ALTR-2025-01530

PANEL LOCATION AND DETAILS

WALL BRACING INADEQUATE

Proposed Basement Floor Plan
Soc 114

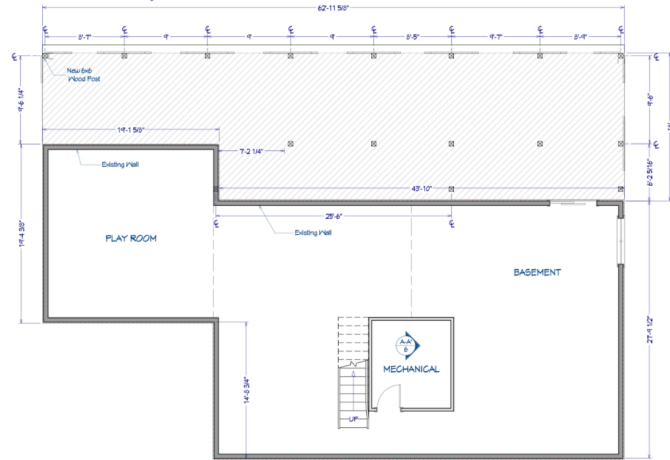
Please provide details to show compliance with the requirements of the code. Construction documents must clearly show all braced wall lines and braced wall panels including methods and location of panels along the braced wall lines. (Ref. 2021 VRC R602.10)
Please note that the plans do not meet the requirements for Continuously Sheathed Portal Frame Panel Construction. Please revise the design. (Ref. 2021 VRC Figure R602.10.6.4)
Please note that the wall bracing shown on the plans does not conform to the requirements of the code. Please revise the location and length of braced panels. (Ref. 2021 VRC R602.10, Table R602.10.3(1) - (4))

Please provide complete sealed calculations for this design, the knee bracing does not appear to be adequate for the lateral bracing
